Office Action Summary

10/561,736

VOGELBACHER ET AL.

DETAILED ACTION

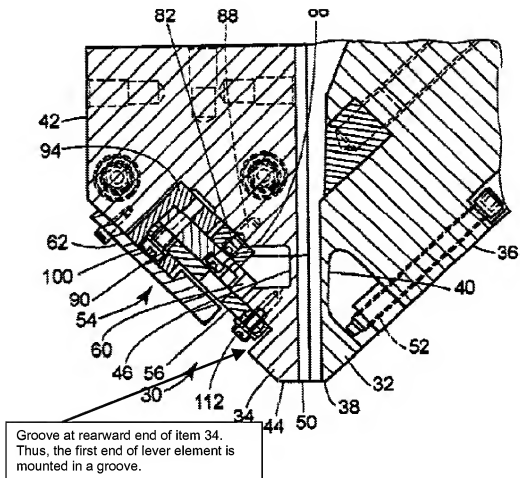
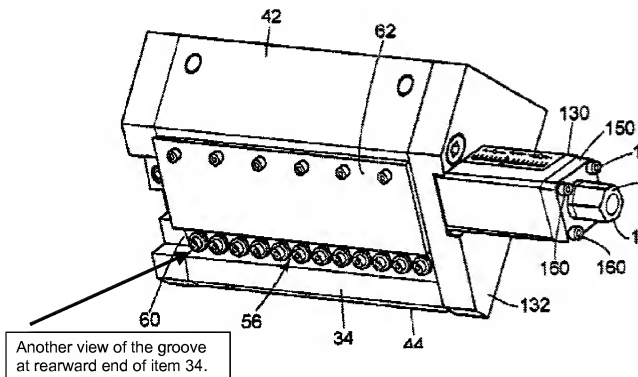
With respect to the reference of Ulcej, however, the Examiner disagrees with the assertion that Ulcej does not teach a groove. A groove, by definition can be a furrow, a channel or a gouge. Ulcej teaches such an element or gouge as shown in the figure

below:

Thus, the Examiner maintains the rejection with respect to the reference of Ulcej.
